Addendum No.: 1

Date Of Addendum: 09/07/18

Master Plan Phase III Renovations and Additions
Norwalk Community College
188 Richards Ave.
Norwalk, CT
BI – CTC – 467

11 VAV HOT WATER COIL PIPING ARRANGEMENT
MS.04 NOT TO SCALE

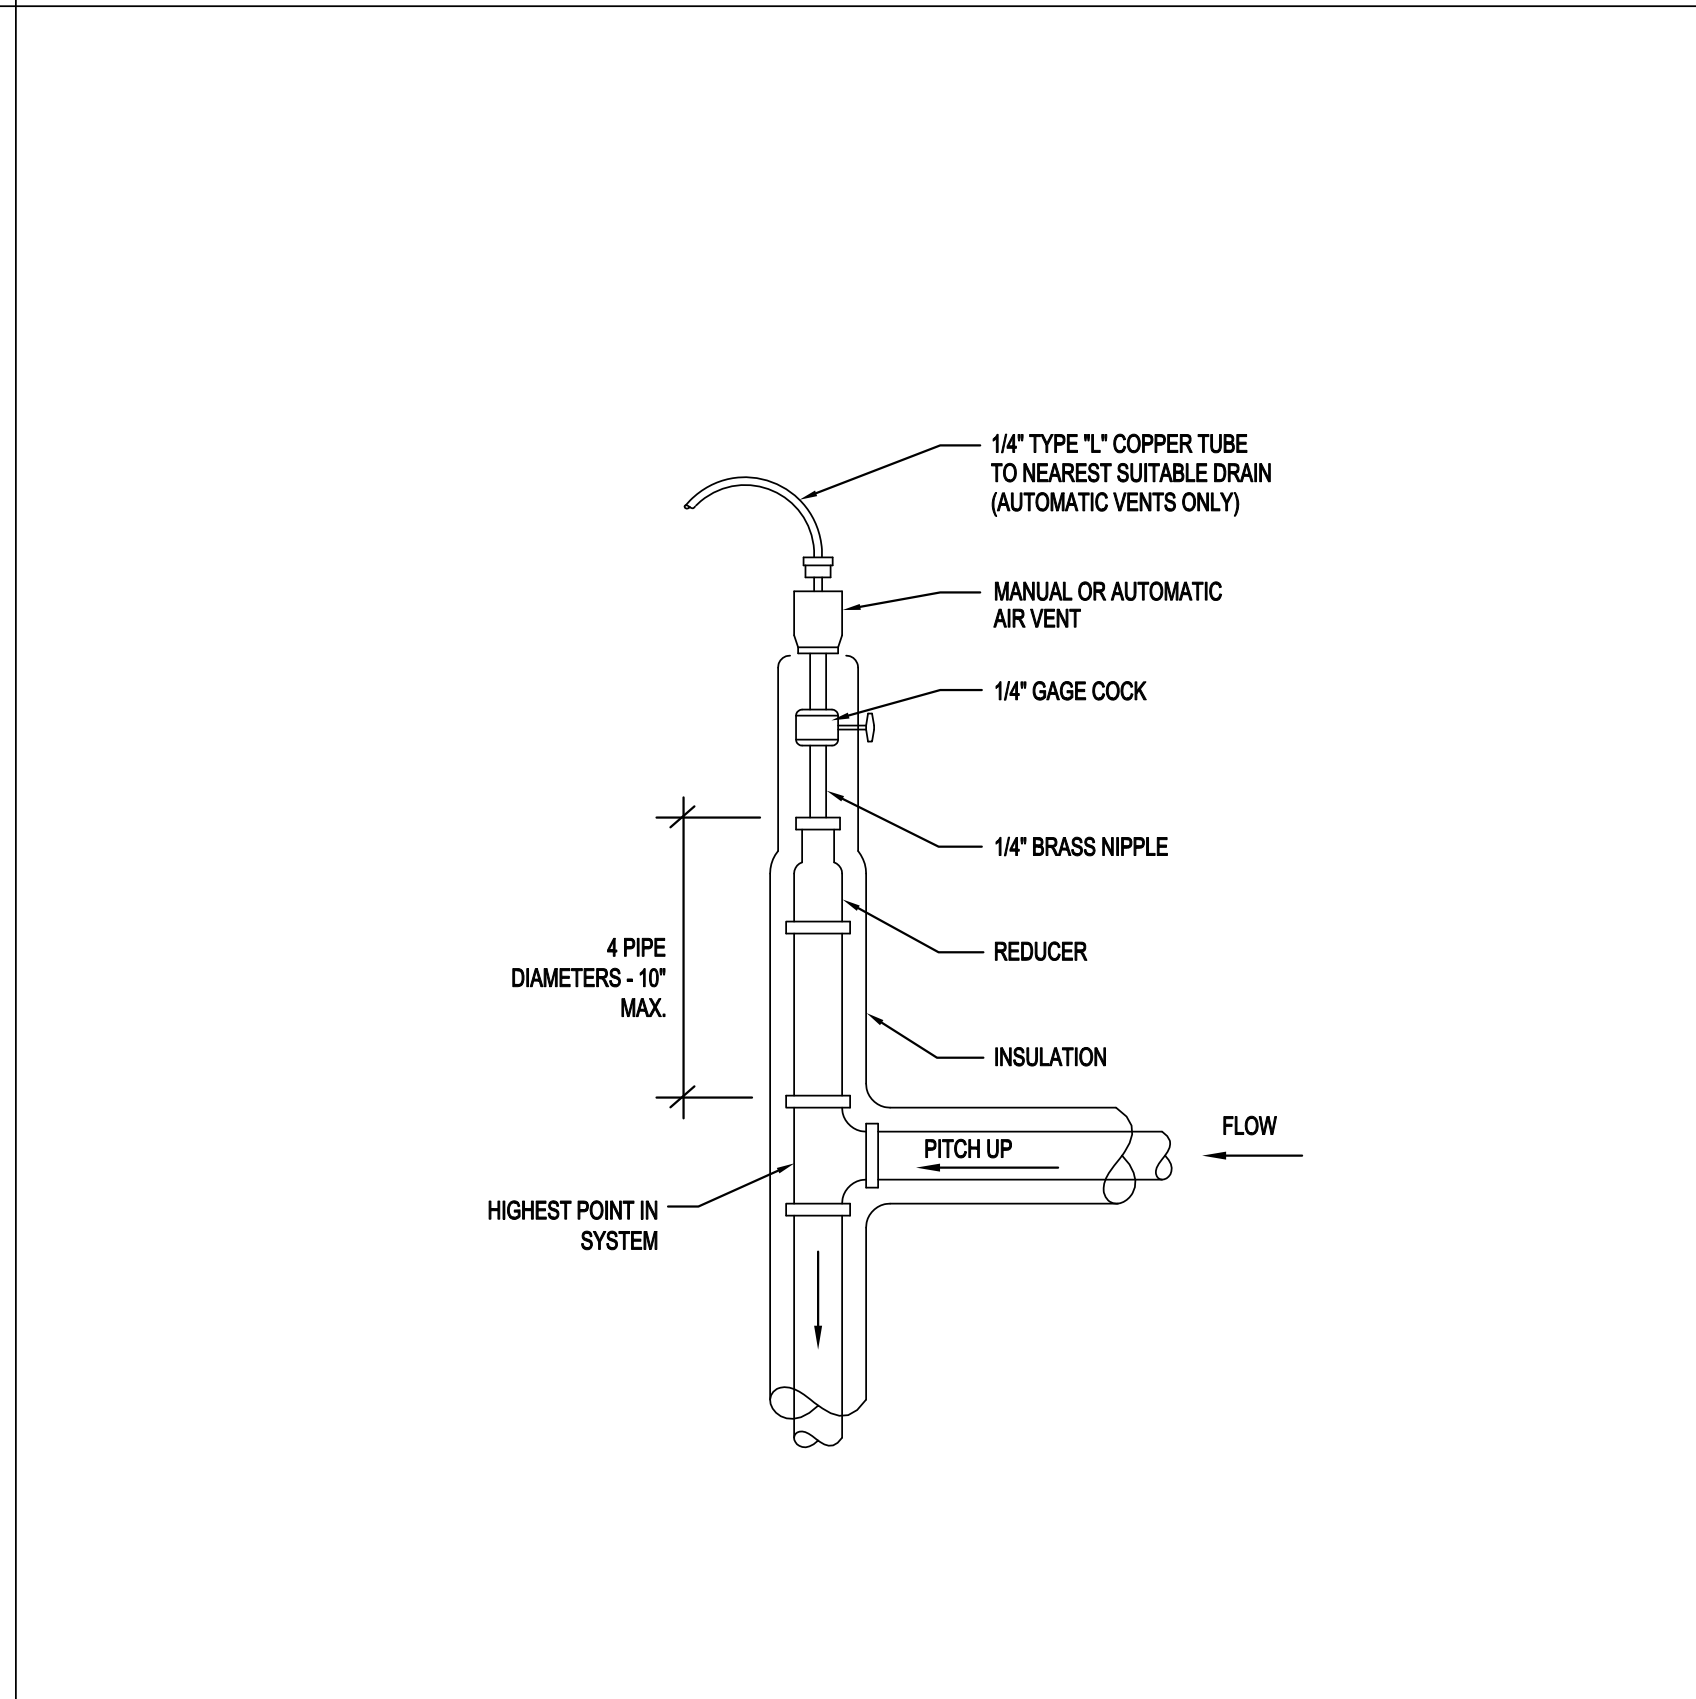
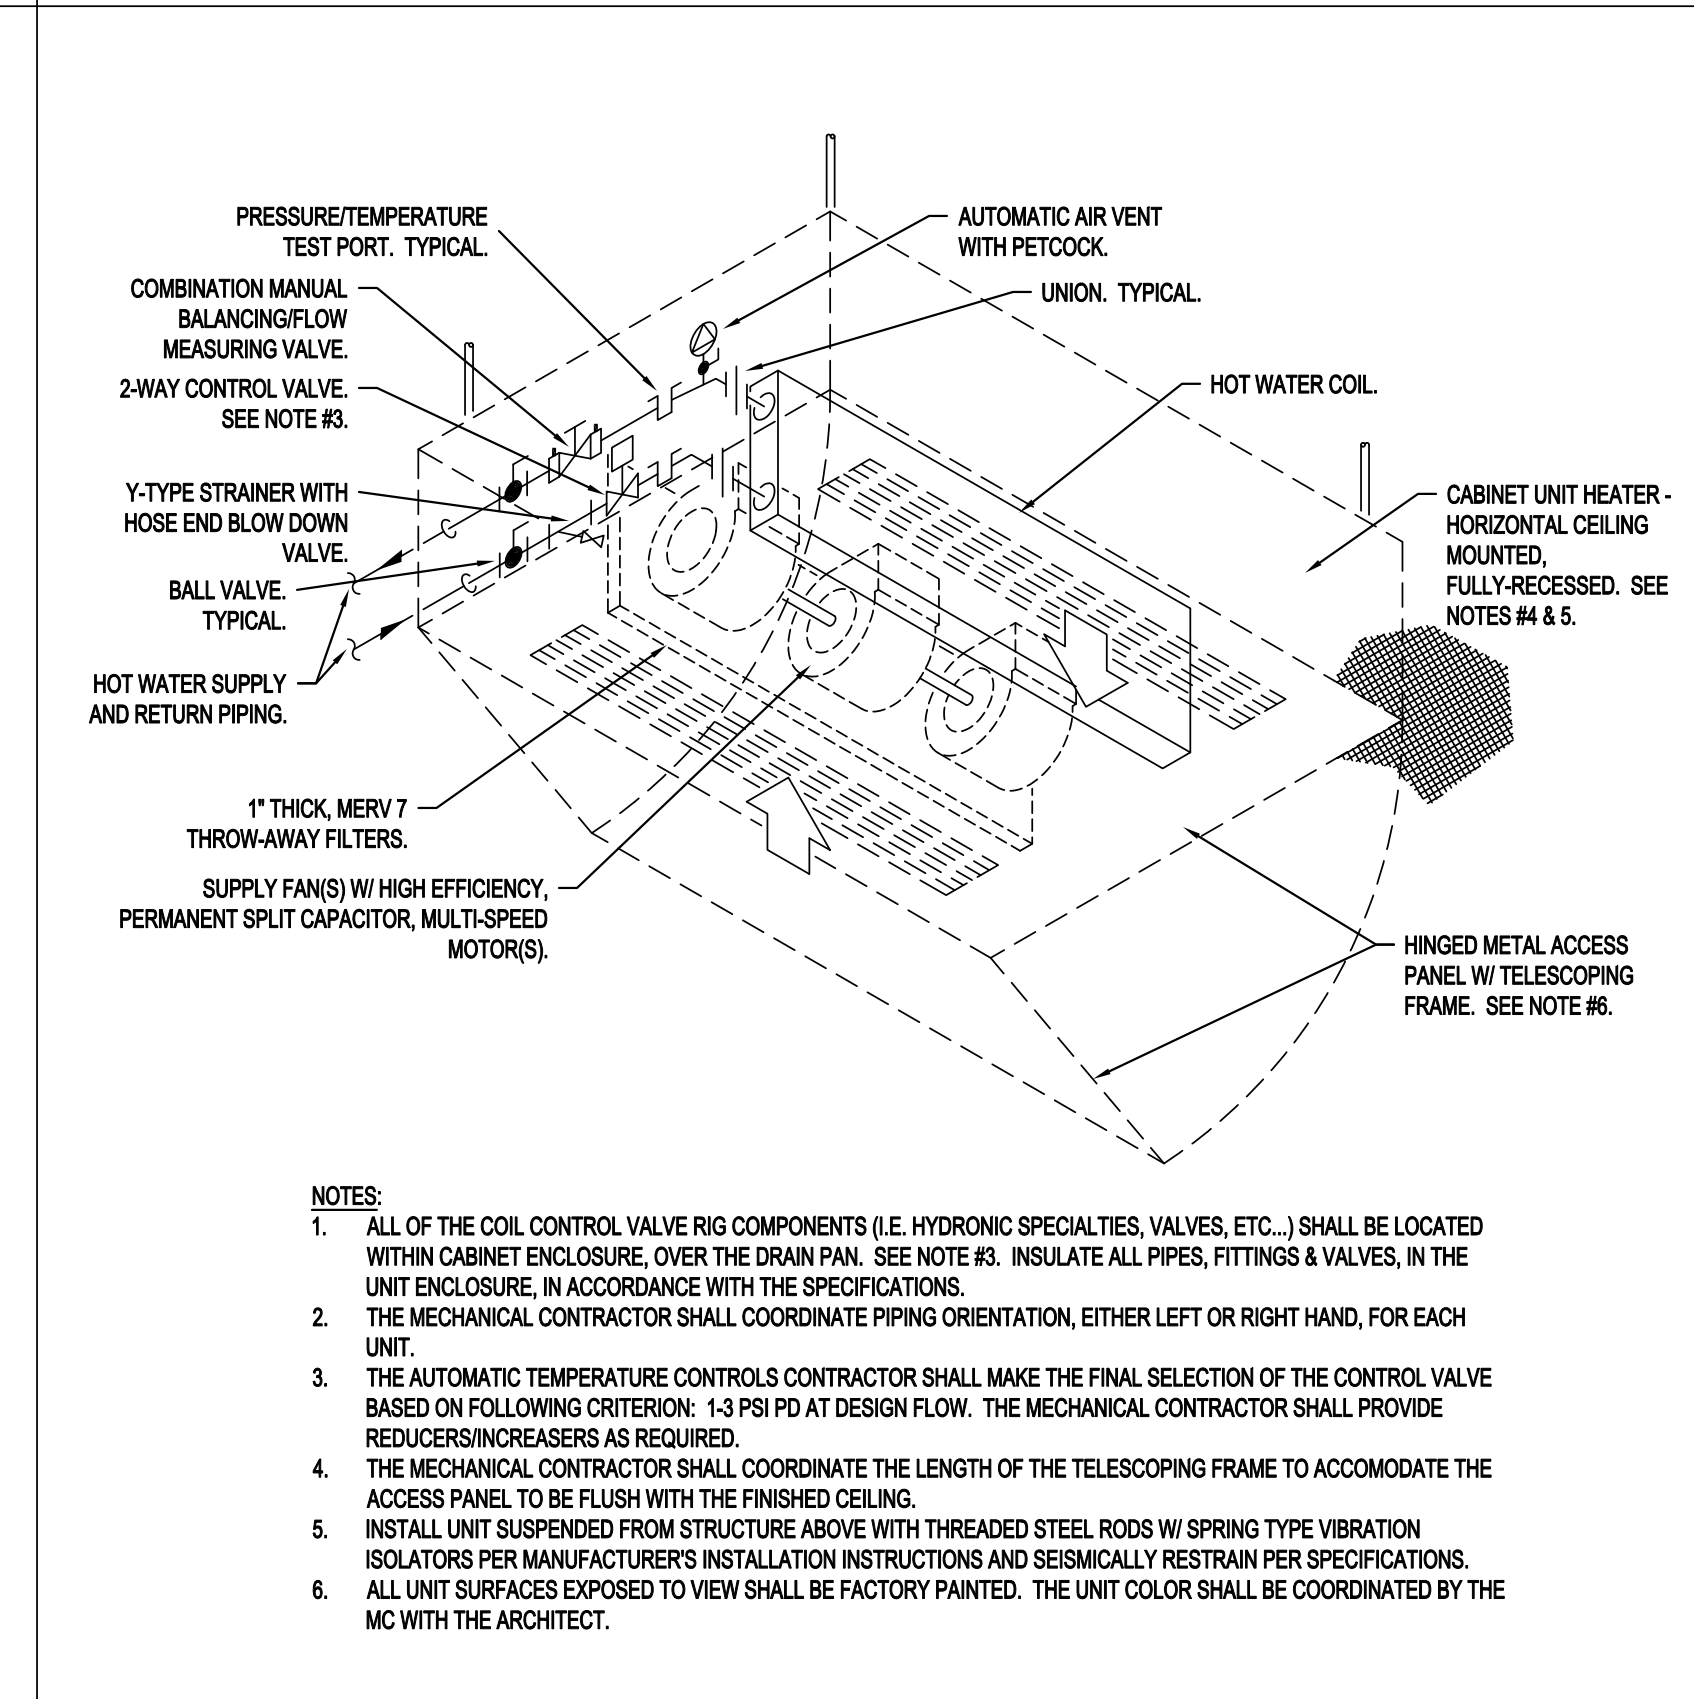
M5.04 – re-issued, Addendum No. 1, 09/07/18: Revised detail 11 to clarify VAV clearance requirements. Revised detail 7 to clarify duct lagging framing.

10 KITCHEN CORRIDOR - EAST ELEV.
SCALE: 1/4" = 1'-0"

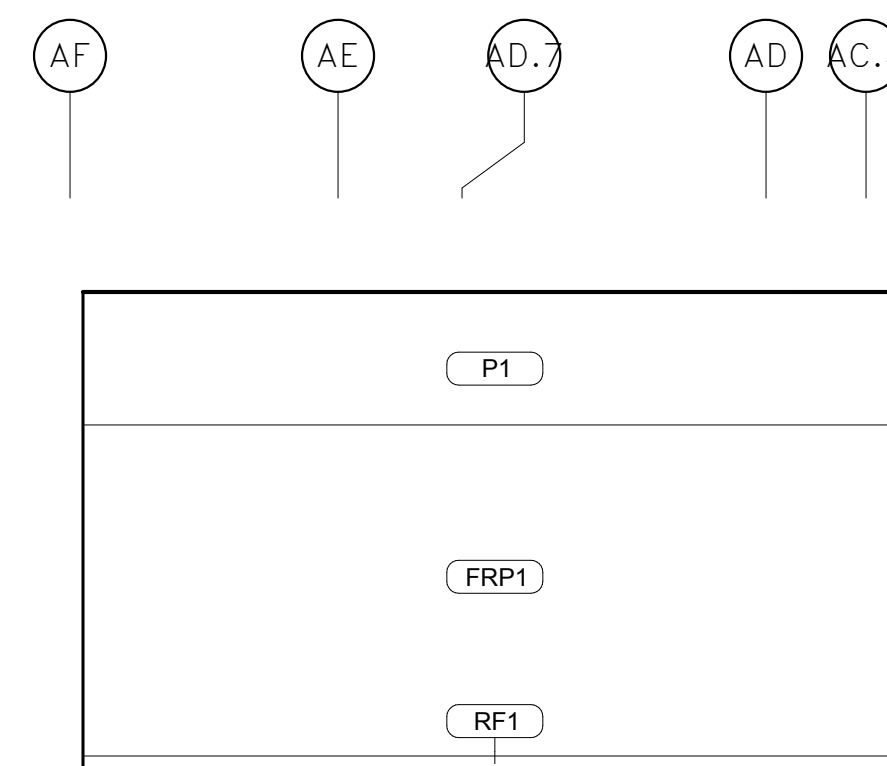
Question: Are the Lockers shown on Drawings A2.01S and A7.03S in the Student Center new or existing? They are not shown on the elevation on detail 10 on Drawing A7.03S.

Response: Lockers shown shall be new, triple tier.

A7.03S - re-issued, Addendum No. 1, 09/07/18: Revised to clarify locker elevation in detail 10.
